FINAL PLAT
REED'S COVE ADDITION
AN ADDITION TO WICHITA, SEDGWICK COUNTY, KANSAS

RE: SUB 2002-57- Final Plat of Reed's Cove Addition

RE: SUB 2002-57-- Final Plat of Reed's Cove Addition

CASE NUMBER: SUB 2002-57 -- REED'S COVE ADDITION

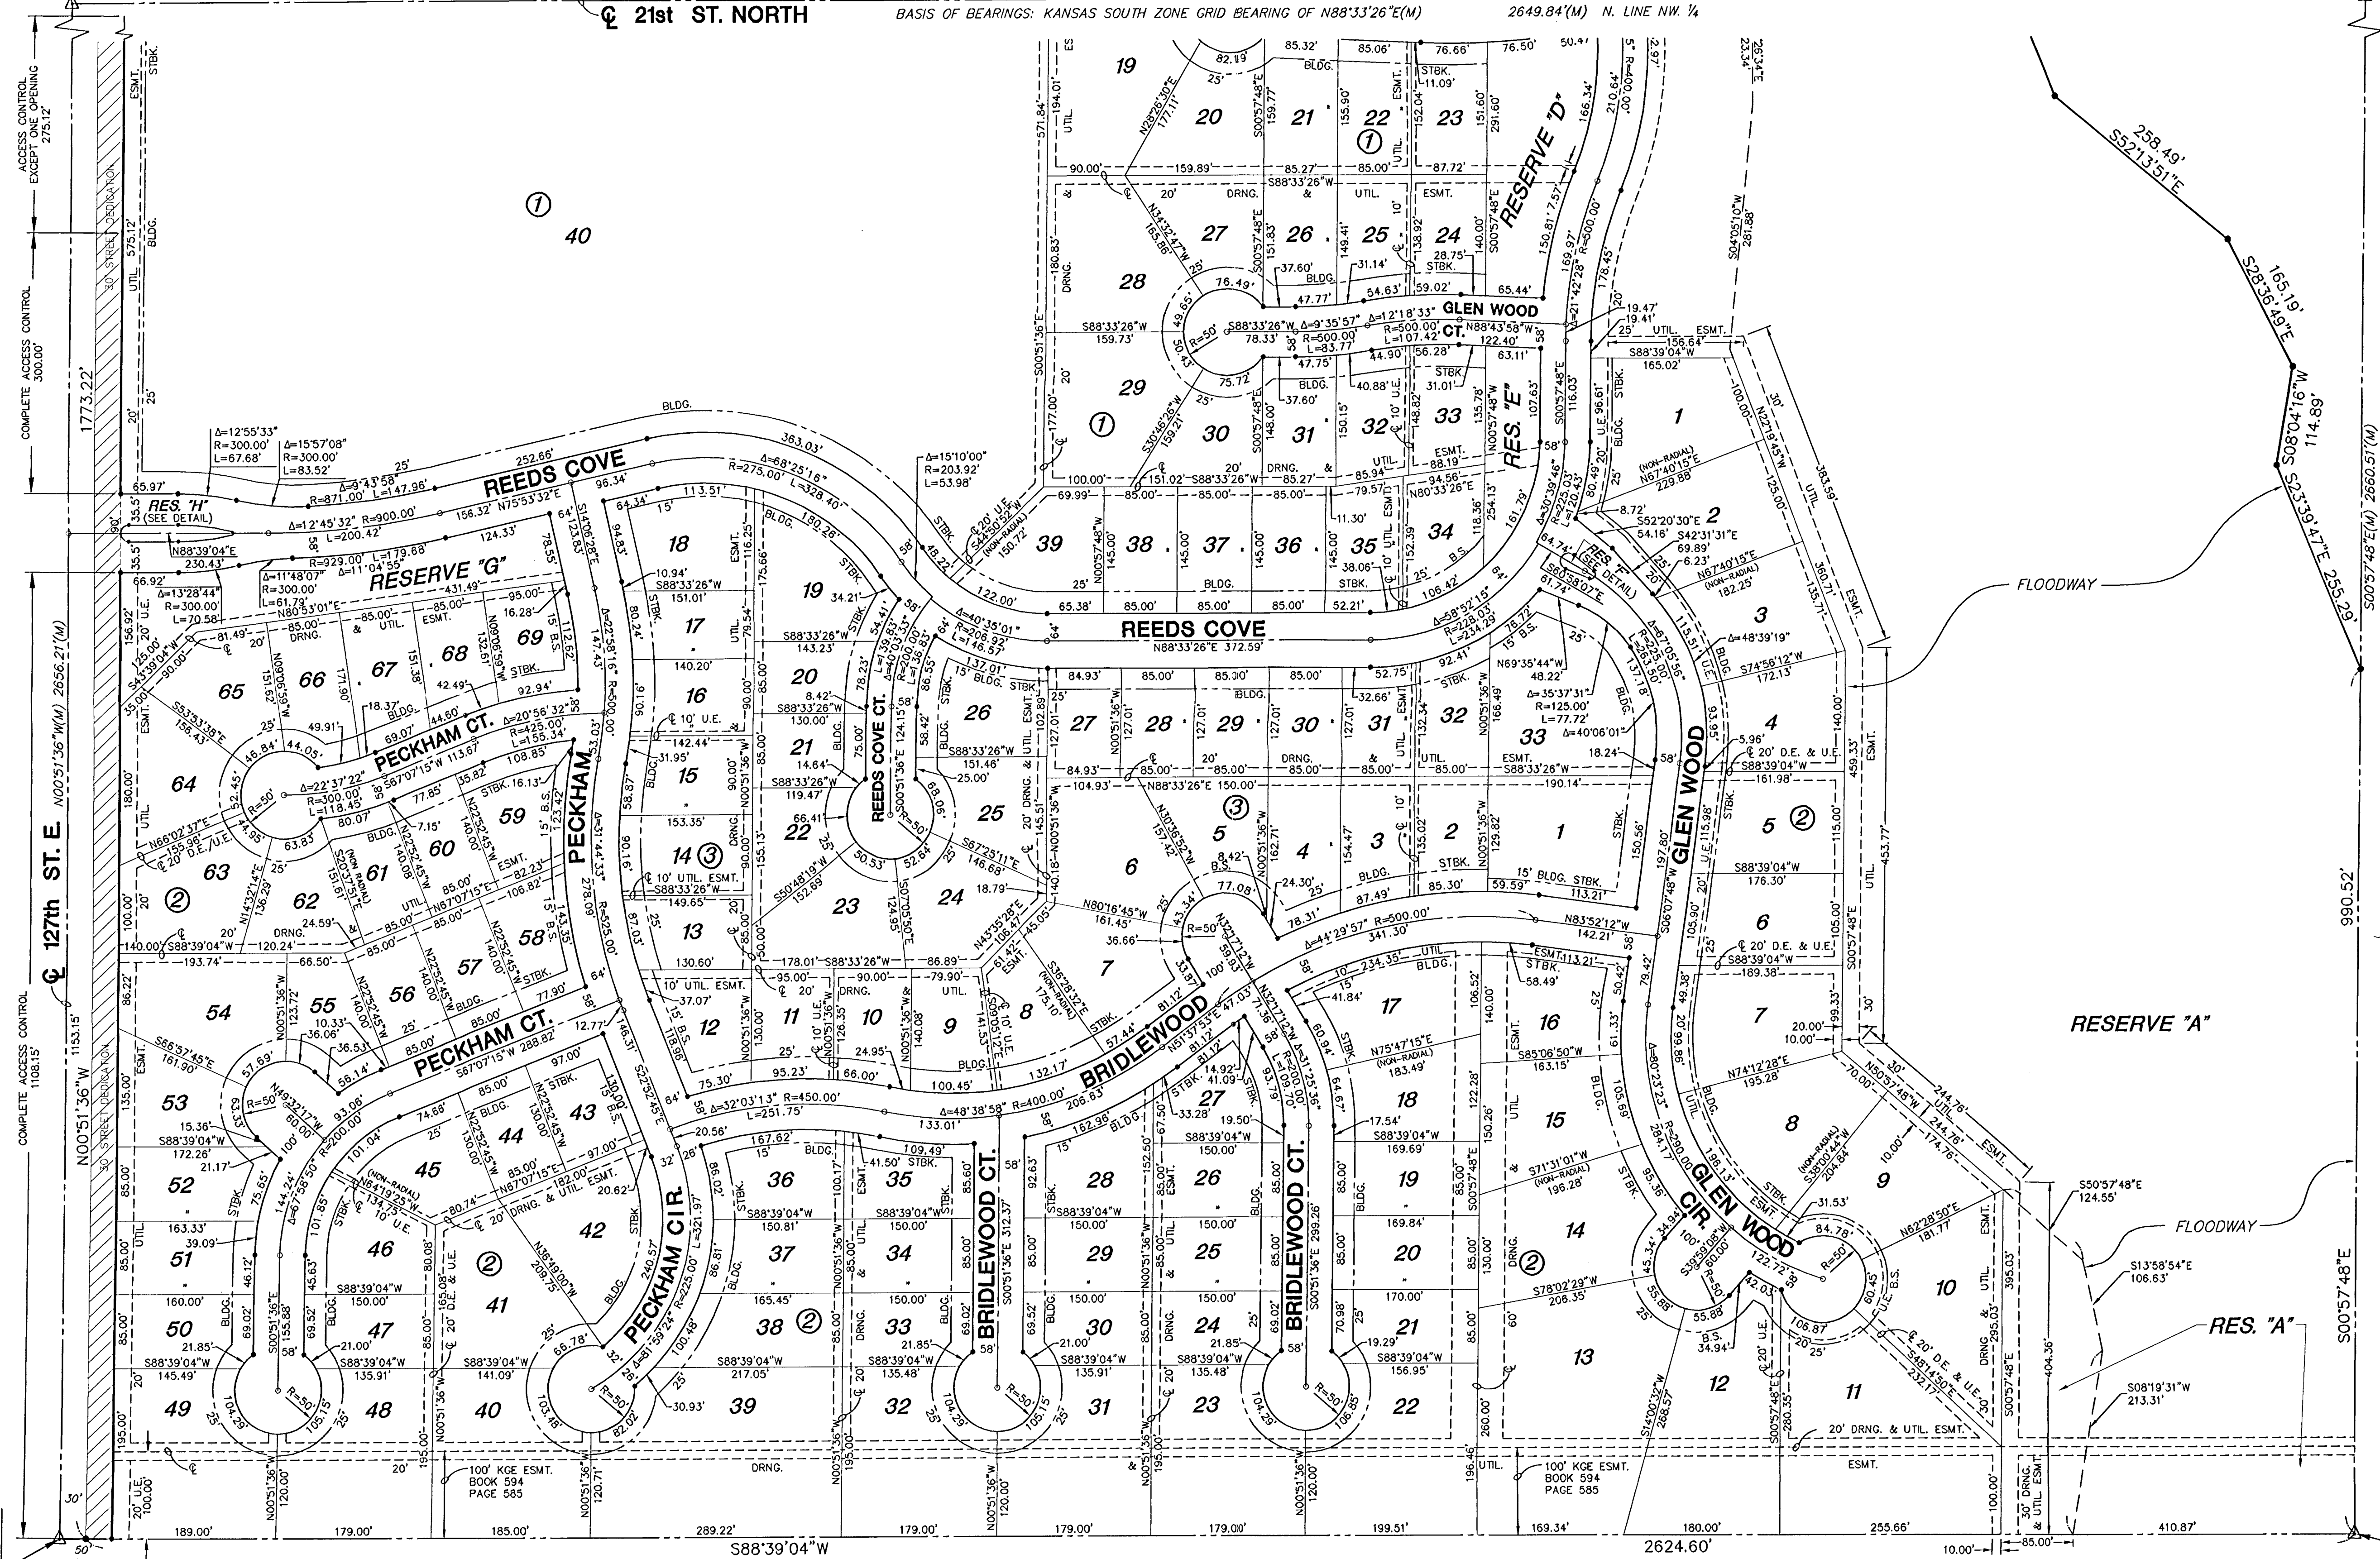
- E. County Engineering needs to see applicant's drainage plan for any effects on 21st St. County Engineering has noted drainage structures along the south property line. A drainage easement is needed. City Engineering has approved the drainage plan. A guarantee is needed.

- F. Complete access control has been platted along the site's frontage to perimeter streets. Traffic Engineering has approved an additional opening along 127th St. East for Lot 40, Block 1. This shall be labeled as "Access control except one opening".

- G. Traffic Engineering has approved all street widths. The 58-ft wide segment of Reed's Cove shall be limited to parking along one side of the street.

- H. Traffic Engineering has requested the deletion of Reserve H located at the entrance to the Addition along 127th St. East. The applicant has reduced the size of Reserve H which is acceptable to Traffic Engineering.

- P. City Fire Department needs to comment on the street length of Woodbridge Ct at the southwestern corner of the site (650 feet). The Subdivision Regulations limit urban cul-de-sacs to 600 feet in length. The street length is approved.

- R. The City Fire Department/GIS needs to comment on the plat's street names. "Reeds Cove" needs to be changed to "Reeds Cove" A new name is needed for Reeds Landing. The Subdivision Committee has approved "Reeds Cove".

- S. "13th St. North" shall be revised to "21st St. North".
- T. The Applicant is reminded that a platting binder is required with the final plat. Approval of this plat will be subject to submittal of this binder and any relevant conditions found by such a review.

At the regular meeting of the Metropolitan Area Planning Commission on September 12, 2002, the above captioned plat was considered. The action of the Planning Commission was to approve the plat as recommended by the Subdivision Committee, subject to the conditions stated in our letter dated August 2, 2002. Item R is replaced with the following:

- R. The applicant and GIS need to reach an agreement on the naming of Reeds Cove and Reeds Landing.
